**TO:** Historic Preservation Board  
**FROM:** Department of Doing, Planning Staff

**Item Number:** 5  
**DATE:** September 5, 2017

**SUBJECT:** **Petition HP-17-40.** Leslie Murray and Sophia Acord, owners. Certificate of Appropriateness for rehabilitation including new roof form, window and door replacement and new fencing for 217 NE 10<sup>th</sup> Avenue. The property is contributing to the Northeast Residential Historic District.

Partial SOUTH ELEVATION  
 SCALE: 1/4" = 1'-0"  
 REAR

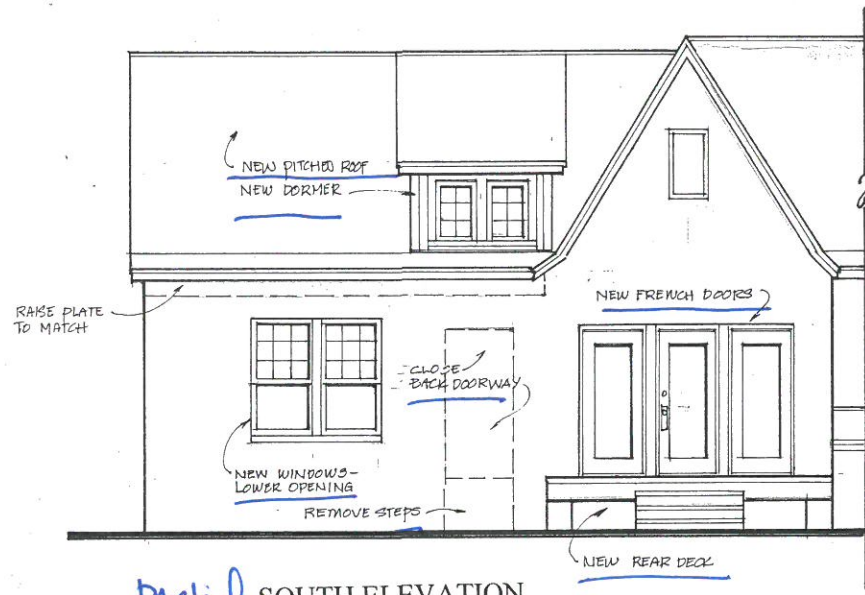
##### 1970s Addition: Rear (south) windows/ Laundry Room window

The existing windows on the 1970s addition are small aluminum 1/1, of the era and are not compatible with the historic windows on the original house (refer to Exhibit 1). The windows will be replaced (refer to Exhibit 2). New windows will be Marvin Integrity; the applicant should verify that the windows will have true divided lights. The rear (south) windows will be 9/1 to

match the original house and will require lowering the existing opening. A new wood single-hung window (36" tall by 43" wide) will be installed in the laundry room hallway on the rear façade of the house.

- New Marvin Integrity windows will have true divided lights.
- Stockade fencing is allowable only behind the existing mature hedge. If the hedge is removed in the future, the fencing must also be removed.

NORTH ELEVATION  
 SCALE: 1/4" = 1'-0"  
 FRONT

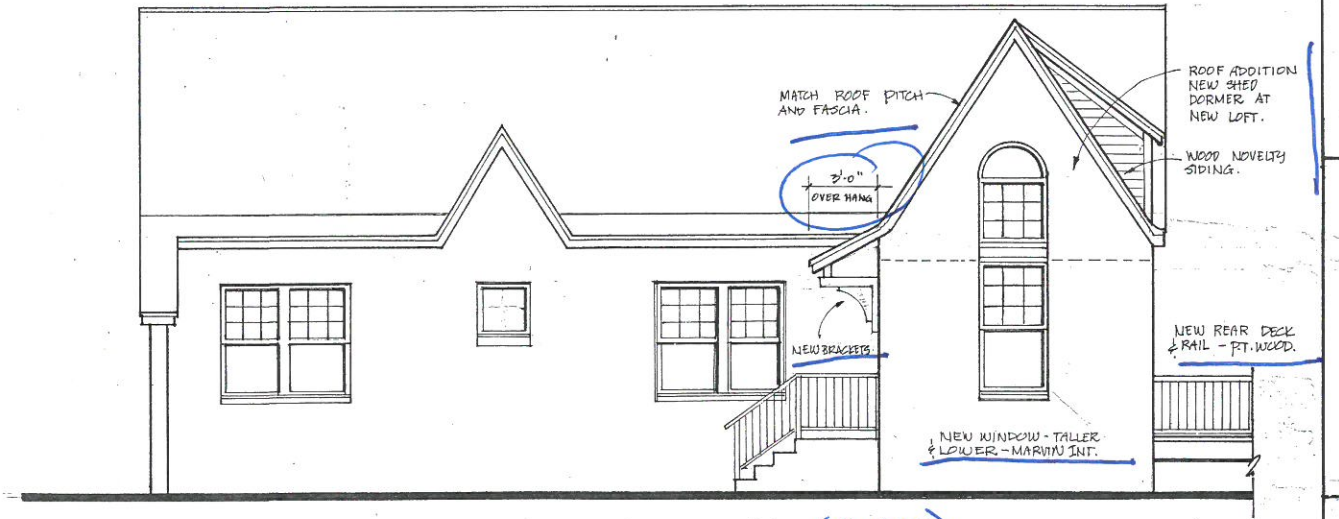
#### 1970s Addition: New door, entry porch and overhang

The front windows on the 1970s addition will be replaced by a new entry, including a pair of 3'-0" x 6'-8" painted fiberglass French doors with true divided lights. The entry will consist of a new porch and stairs, 8'-0" wide by 6'-0" deep (including the steps), and a roof overhang with new brackets. The guidelines for entries state: *Alterations to non-historic portions of contributing buildings provided they are compatible in scale, design and materials with but distinguishable for the historic proportions.* Though the proposed entry is visible from the street, it is located on the 1970s addition (considered non-historic), which is recessed beyond the face of the original house. The new door, entry porch and overhang provide a compatible design with the architecture of the original house. Staff finds the proposed door and entry porch meet the guidelines.

WEST ELEVATION (SIDE)  
 SCALE: 1/4" = 1'-0"

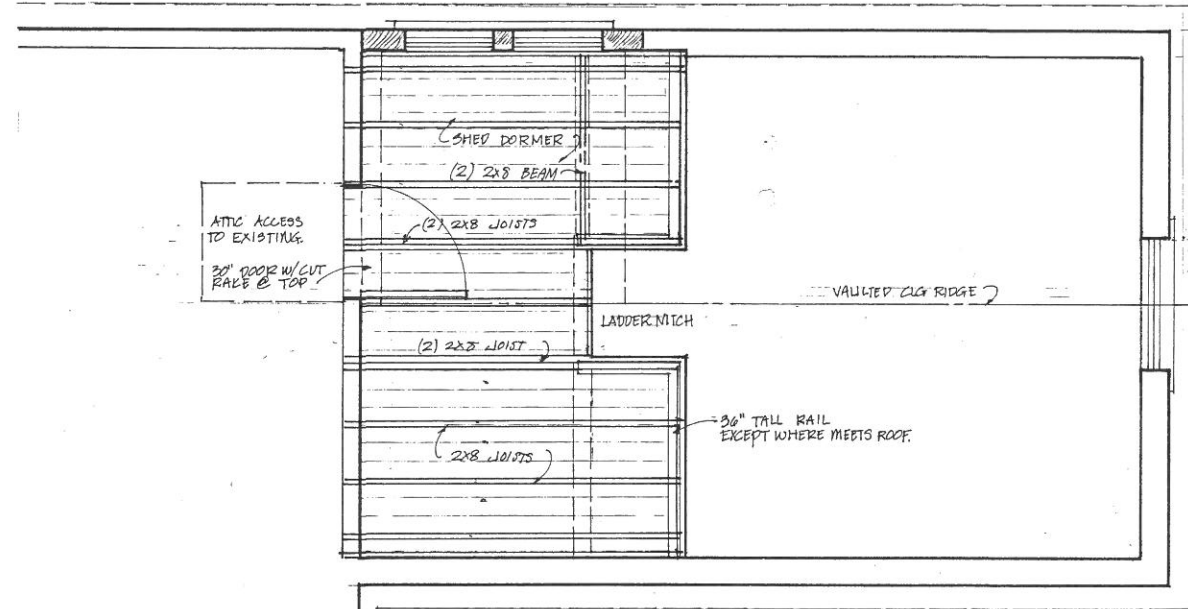
#### **1970s Addition: Combination window (west façade)**

The window on the gable side (west) of the wing will be a combination window, including 9/1 and a 9-pane upper sash, allowing light into the double-height space. Window guidelines state: *New windows on additions should be compatible with those of the nearest window on the historic building in terms of proportions, frames, sills and lintels. Installing window designs reflective of a historic period is discouraged. Designs that match the proportions of existing historic windows, but are simple in detailing, are preferred. New window openings are inappropriate on the principal facade(s); new openings should be placed on secondary elevations.*

The new combination window is of compatible style with the historic windows; while its double-height design reflects the interior space, it is also reflective that this is a new addition to the historic building. *Each property shall be recognized as a physical record of its time, place and use. Changes that create a false sense of historical development...shall not be undertaken* (Secretary of interior's Standard #3). Further, the new window's placement on the side elevation of the 1970s addition means it does not impact the historic appearance of the original house. Staff finds the proposed roof form and gable windows meet the guidelines.

SITE PLAN  
SCALE: 1" = 20'-0"

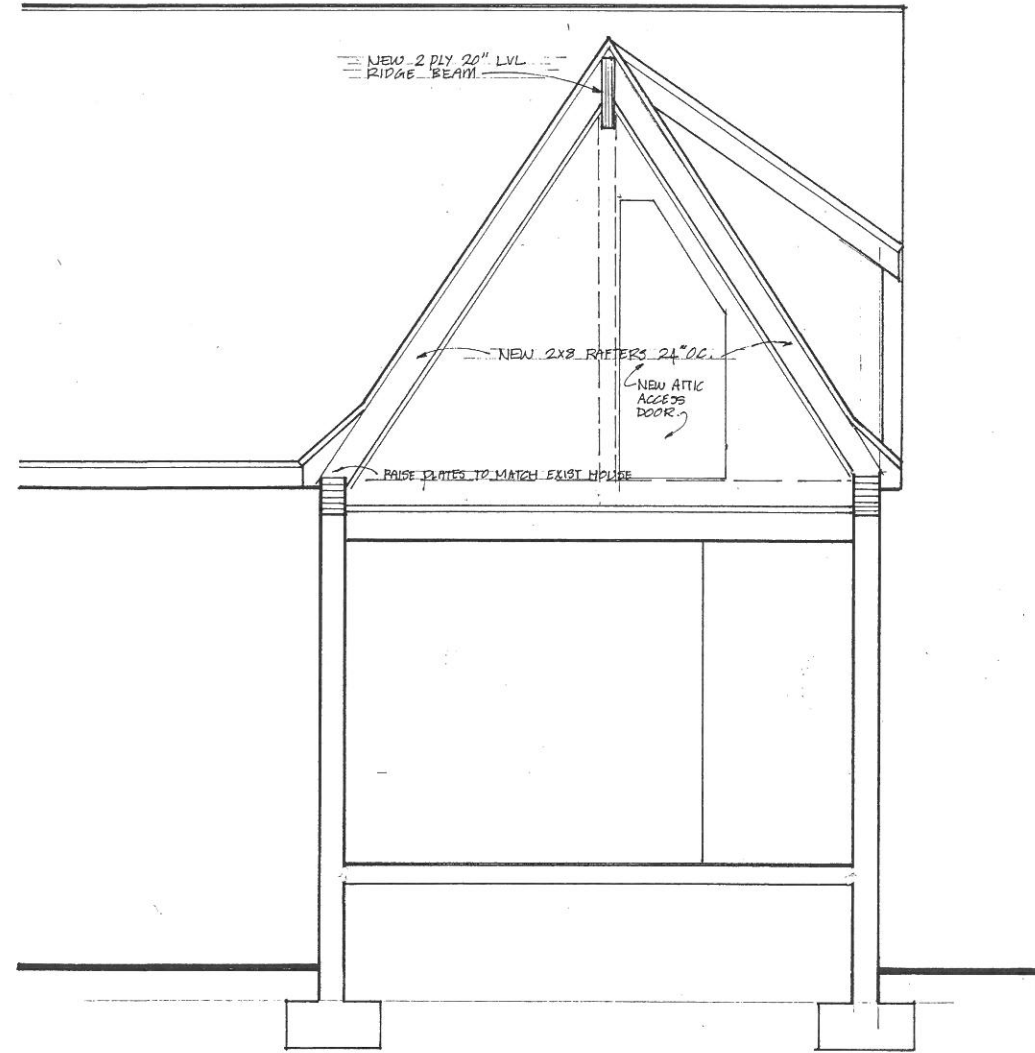
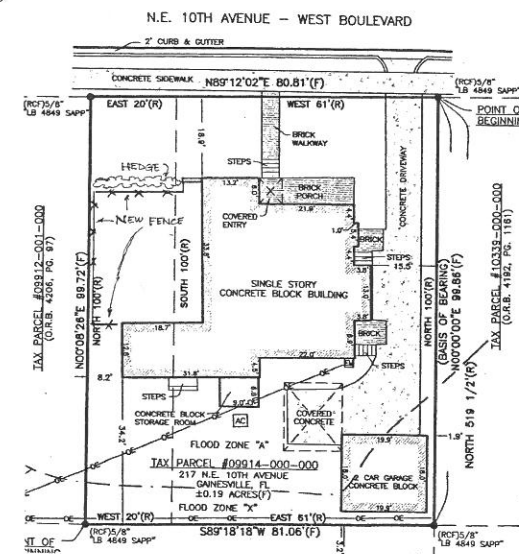
#### New Wood Fencing & New Wood Gate

The applicant proposes a 6'-0" wood stockade fence behind an existing hedge, aligned with the front wall of the building. A new wood gate will be installed in the existing arched opening. The gate will be designed with a half-circle at the top, reflecting the existing arch of the wall.

Staff finds the custom-designed gate appropriate for the existing wall. Staff finds the stockade fencing only appropriate as it will be screened by the existing hedge. Staff recommends approval of the stockade fencing with the condition that it remain behind the existing hedge. If the hedge is removed in the future, the fencing must be removed, as well.
